S19AG

Subject: S19AG, Air Conditioning Relay

Models Affected: Model Year: Certain 2015 to 2021 (School Bus and Non-School Bus)
Model: Vision and All American

S19AG Air Conditioning Relay -Revision A

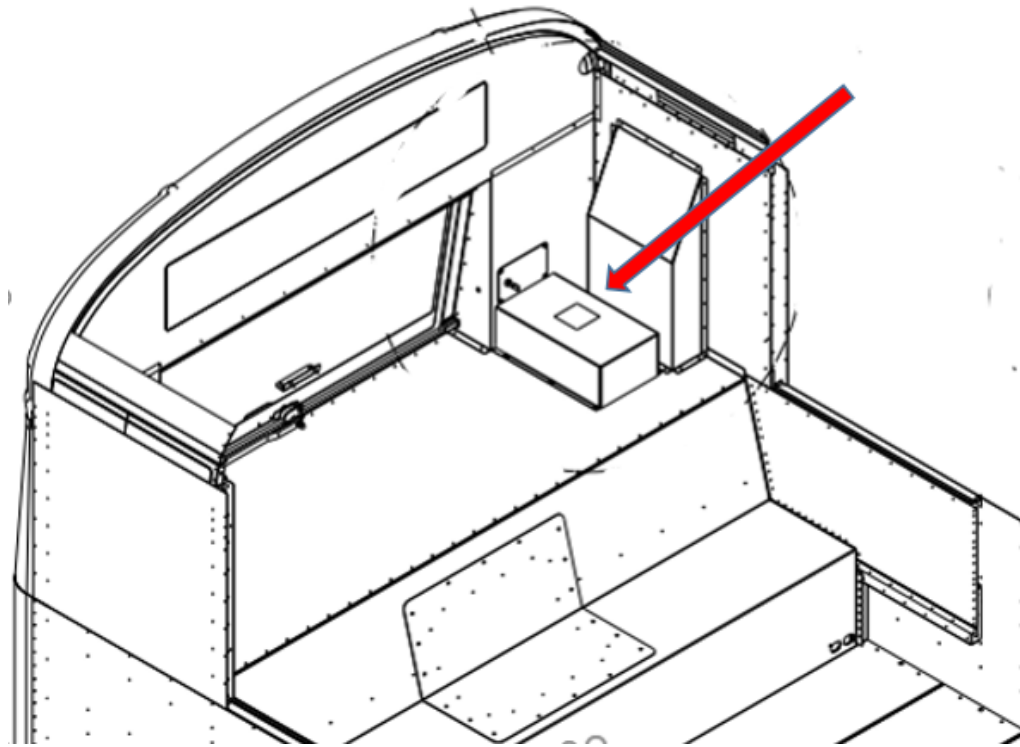
1. Locate the air conditioner relays and harness assembly.
 - a. For Vision and Front Engine All American the relays are in air conditioner electrical compartment which is on the left-hand skirt panel rear of the battery compartment.

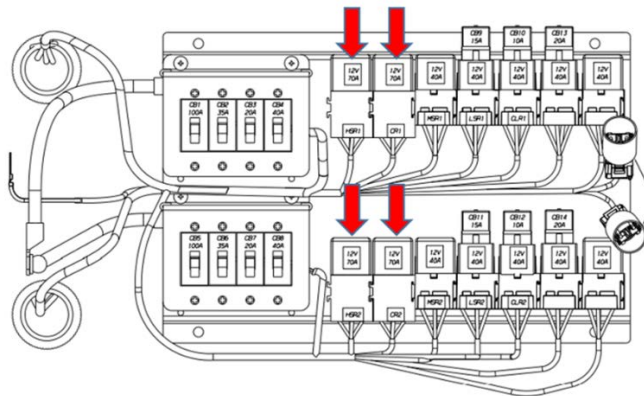
2. Open the compartments and locate the four relays indicated that are used in the air conditioning circuit.

3. Remove the CIT brand relays and replace with the Song Chuan brand.
4. Inspect harness connected to the relay base for any sign of damage and replace, if necessary.
